TECHNICAL SERVICE BULLETIN

Technical Service Bulletin: 225-0970

Forest River is alerting you to an issue involving certain 2018 through 2019 – Crossfit – CFB22CF, CFB22CFEB, CFB22CFEBCA, CFB22DF, CFB22DFEB Class B motorhome recreational vehicles. Please see the information below which describes the issue and provides you with details on the steps you should take to have your vehicle repaired.

3. ADJUSTING THE SPRING POSITION

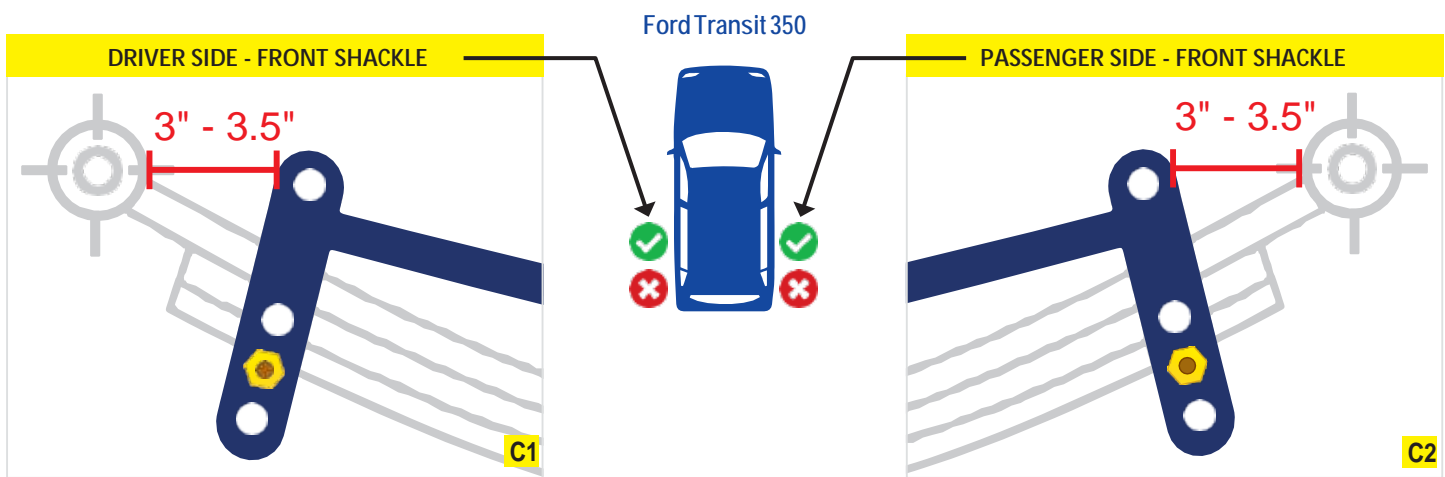
- A. Using a ½" wrench and socket loosen the attaching bolt on the poly spring pad lock down clamp located at the center of the SuperSprings. Do not remove hardware. (SEE IMAGE A)
- B. Place a pry bar behind the rear of the SuperSprings with the end against the cross member. (SEE IMAGE B)

- C. Push the SuperSprings forward with the pry bar to obtain a measurement of 3" to 3.5" between the front of the SuperSprings and the rear of the vehicle front spring eye. (SEE IMAGE C1 AND C2)
 - D. Using a ½" wrench and socket retighten the attaching bolt on the poly spring pad lock down clamp located at the center of the SuperSprings originally loosened during step 3-A.
4. Repeat the same process on the other side if necessary.
 5. **LOWER THE VEHICLE**
Jack up the vehicle, remove the jack stands, and then lower the vehicle to the ground. Remove the blocks from front and rear of the front wheels.
